**FINAL DRAINAGE LETTER for
CROSSROADS MIXED USE FILING NO. 1
UNDERGROUND DETENTION**

DECEMBER 2022

RE: Drainage Letter for Crossroads Mixed Use Filing No.1 Underground Detention

CROSSROADS MIXED USE FILING NO. 1 FOR UNDERGROUND DETENTION (UGD) PROPOSED UGD CONDITIONS DRAINAGE MAP

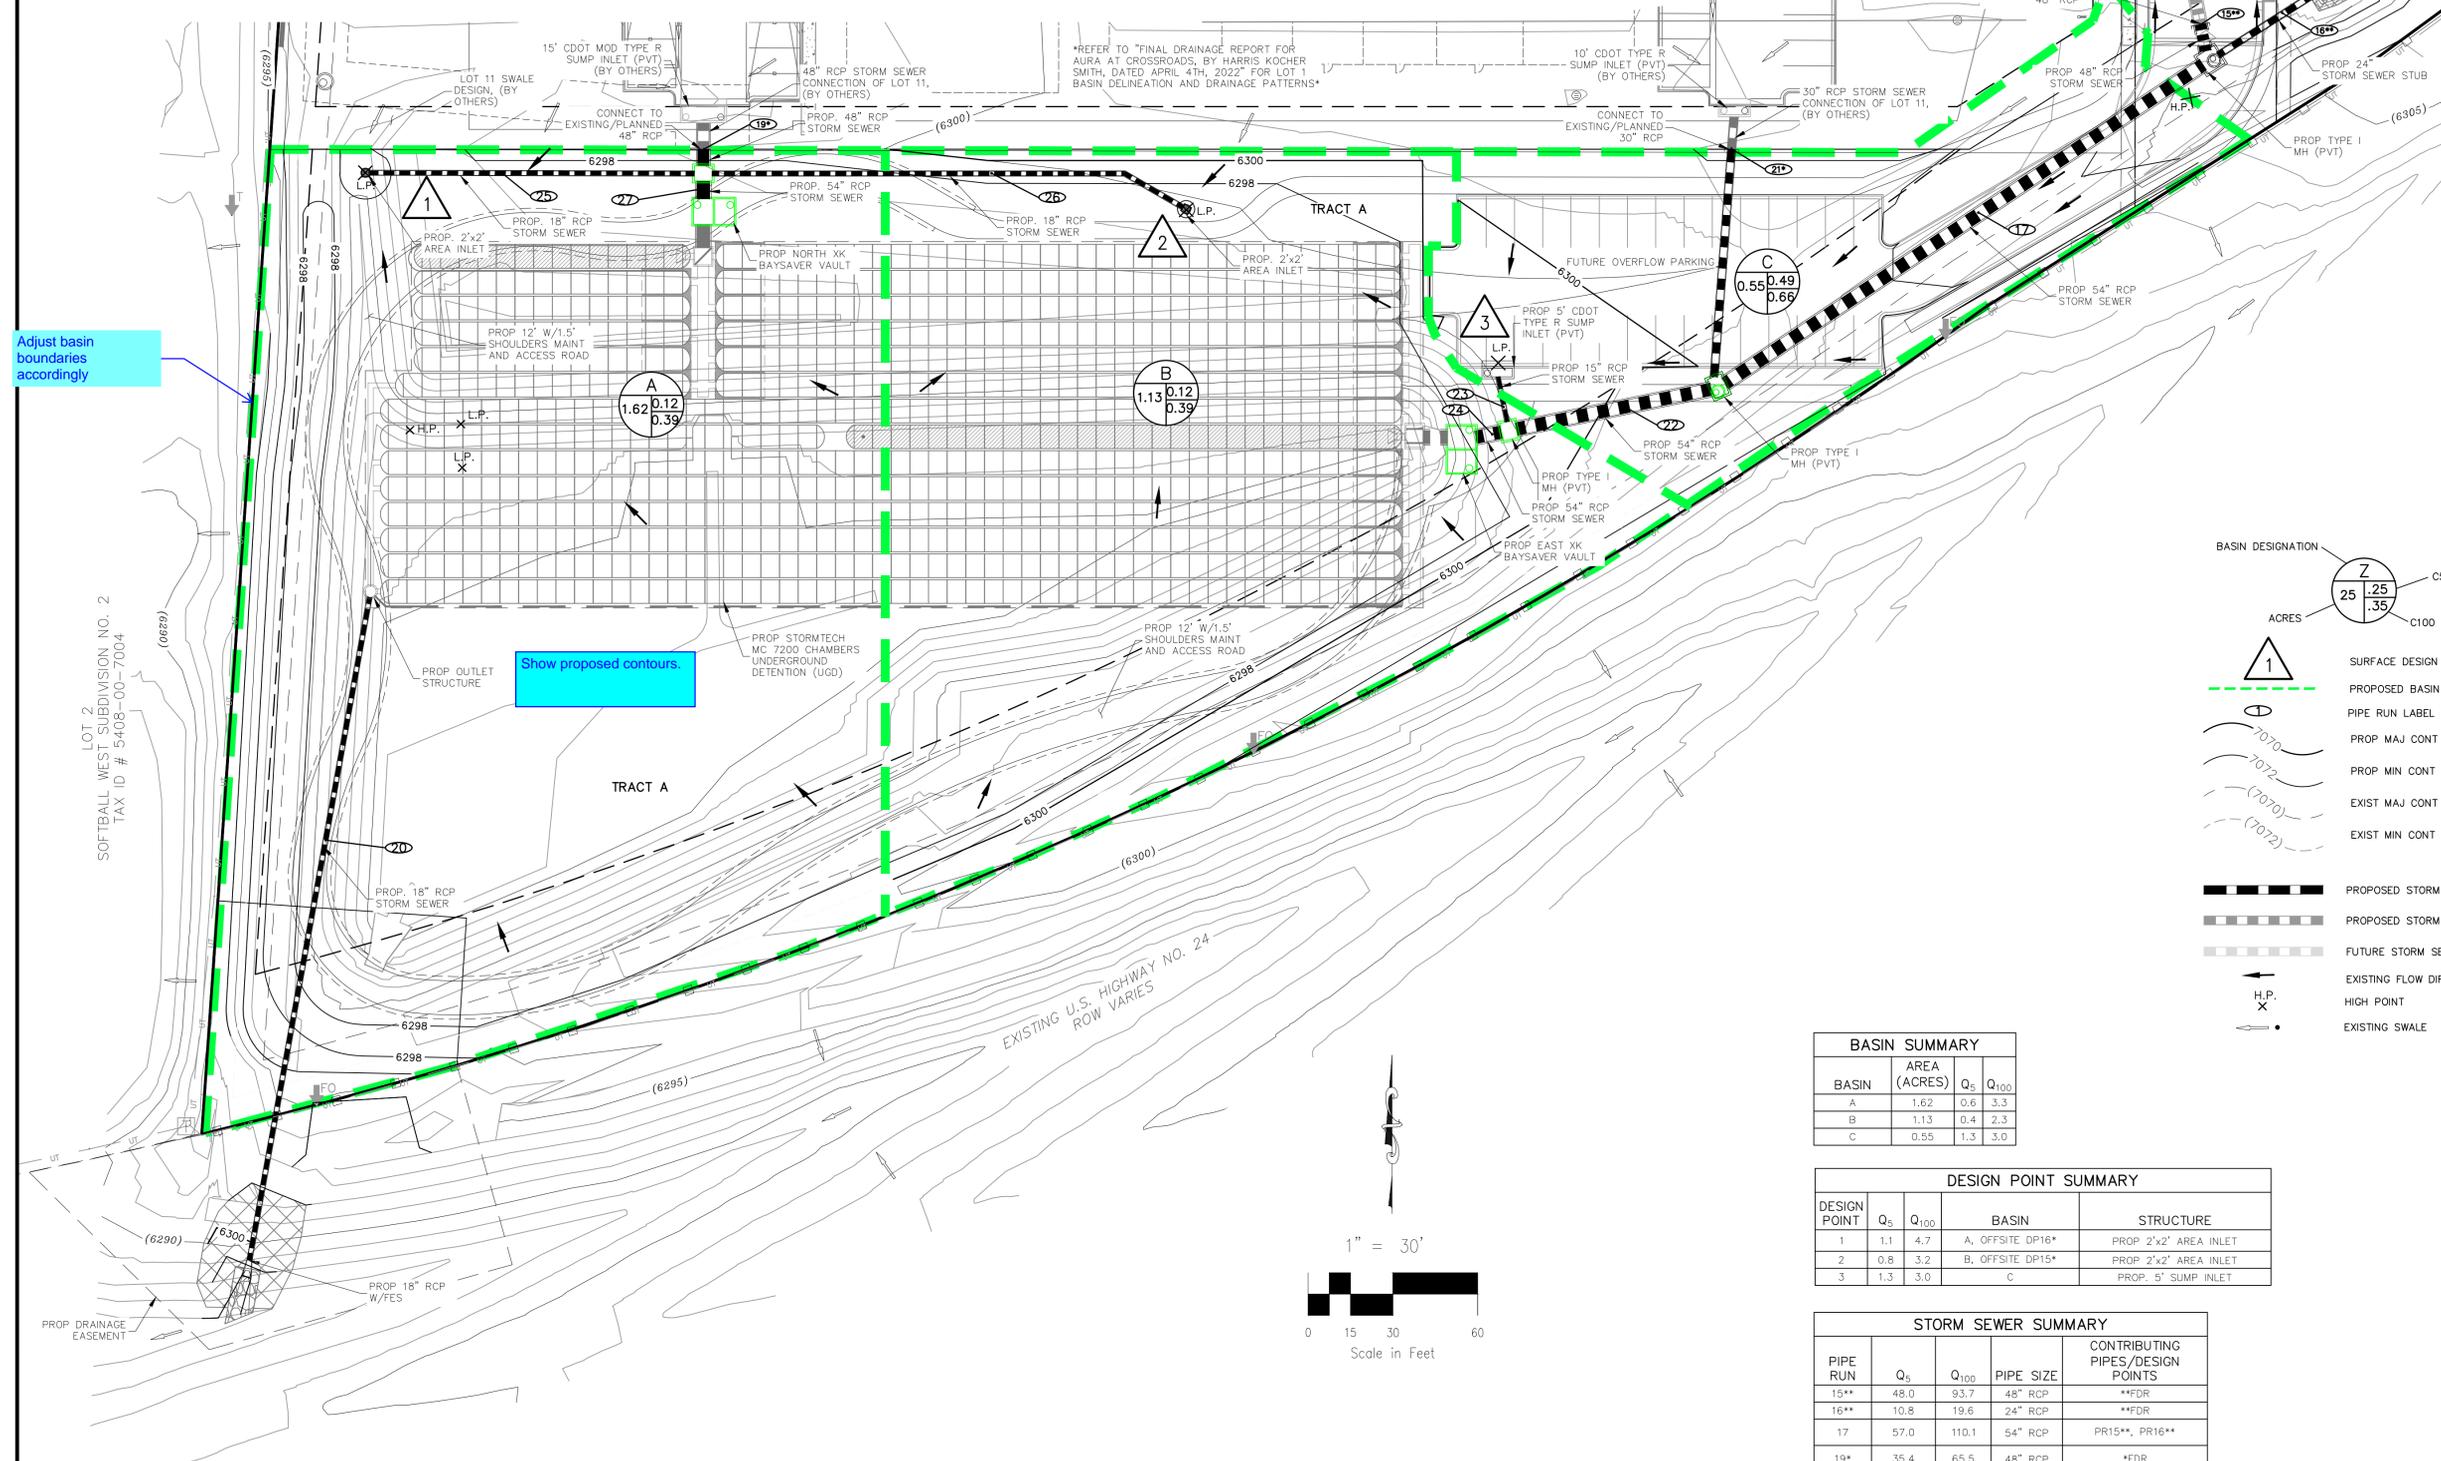
Adjust basin boundaries accordingly

Show proposed contours.
